**IN THE DRAWINGS**

### REMARKS

*Annotated Sheet***FIG. 1A (RELATED ART)**

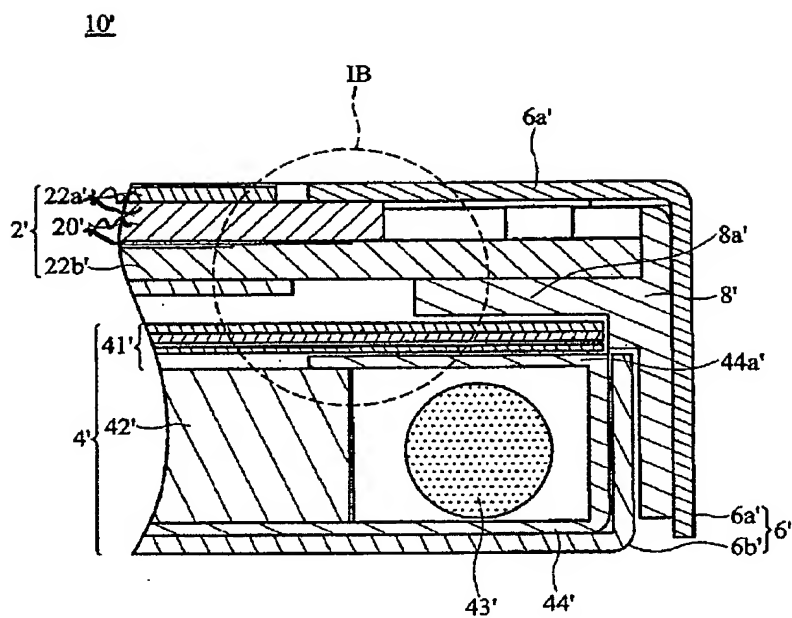
Please replace Figs. 1A, 2A, 2B, 3A and 3B with corrected drawings in the attached sheets. In these drawing sheets, minor changes have been made to lead line and reference designators, as shown in the annotated drawing sheets.

The drawings are corrected according to the description of the specification. Specifically, minor changes are made to lead lines and reference designators of the drawings, as illustrated in the accompanying annotated and replacement drawing sheets.
